76TH AVENUE SW & LONE WILLOW DRIVE
SW IMPROVEMENTS
IN THE CITY OF CEDAR RAPIDS, LINN COUNTY, IOWA

STAGING AND TRAFFIC CONTROL PLAN -
PHASE 3
PROJECT NO: 10466-23

SHEET
1.03

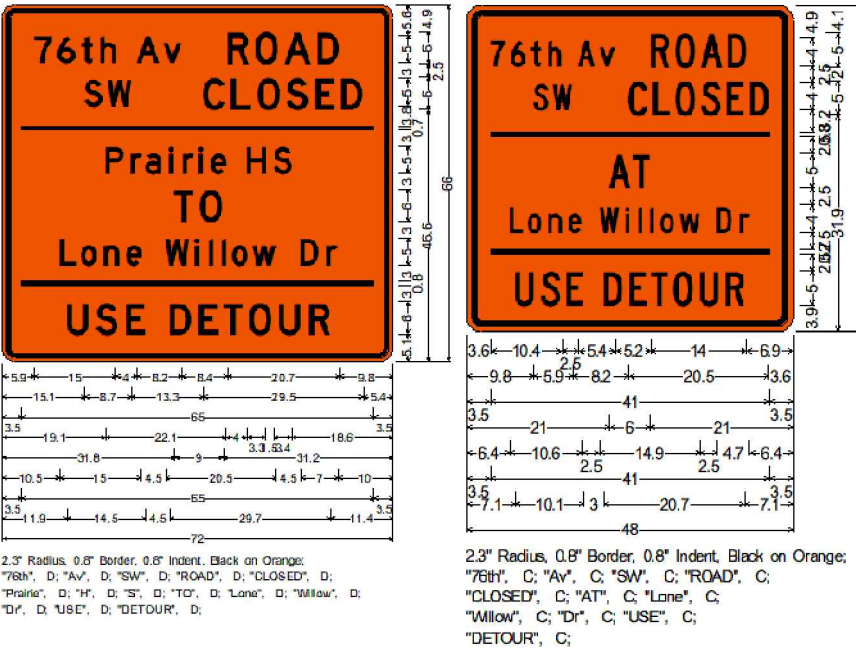
DRAWN BY:	AMJ	ADDENDUM #1	MGJ	03/20/25
CHECKED BY:	MGJ			
APPROVED BY:	MGJ			
DATE:	03/25/2025			
FIELD BOOK:	NO.	REVISION DESCRIPTION	APPROVED	DATE

- NOTES:
1. All M4-9 signs along Kirkwood Blvd and 76th Ave shall be 30"x24". All M4-9 signs along 6th St and Wright Bros Blvd shall be 48"x36".
 2. All auxiliary street name signs (W16-8) connected to detour signs along Kirkwood Blvd and 76th Ave shall be 30"x8" with 4" capital letter height. Along 6th St and Wright Bros Blvd, those signs shall be 48"x12" with 6" capital letter height.
 3. Set road closure signs on Type III barricades as close as practical to construction limits to maintain access into Prairie Heights Elementary driveway.
 4. Coordinate with YMCA site contractor to allow access into their construction site.
